New Albany Architectural Review Board
Monday, February 12, 2024 Meeting Minutes - Approved

ARB-001-2024 Certificate of Appropriateness with Waivers

**Architectural Review Board Staff Report
February 12, 2024 Meeting**

**CERTIFICATE OF APPROPRIATENESS & WAIVERS
BALANCED FAMILY ACADEMY**

Traditional Commercial (UCC Section 2.87)

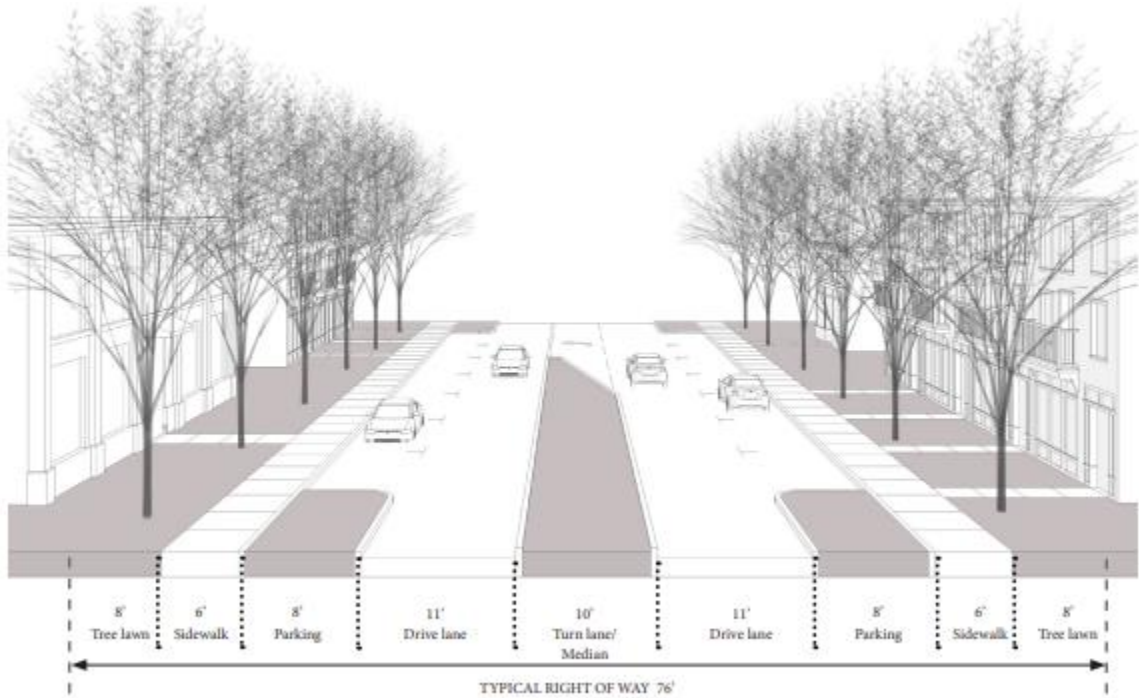
Standard	Minimum	Maximum	Proposed
Lot Area	No min	No max	0.969 acres
Lot Width	No min	200'	Main Street: 213+/- feet [does not meet code, waiver requested]
Lot Coverage	No min	100%	83% [meets code]
Street Yard	0'	20'	Main Street: 16 feet [meets code] Miller Ave: 5 feet [meets code]
Side Yard	0'	20'	Southeastern: 130 feet [does not meet code, waiver requested]
Rear Yard	15'	No max	Southwestern: 55 feet [meets code]
Bldg. Width	80%	100%	Miller Avenue: 71.3% [does not meet code, waiver requested] Main Street: 75% [does not meet code, waiver requested]
Stories	2	3	2.5 [meets code]
Height	No min	55'	43' 4" [meets code]
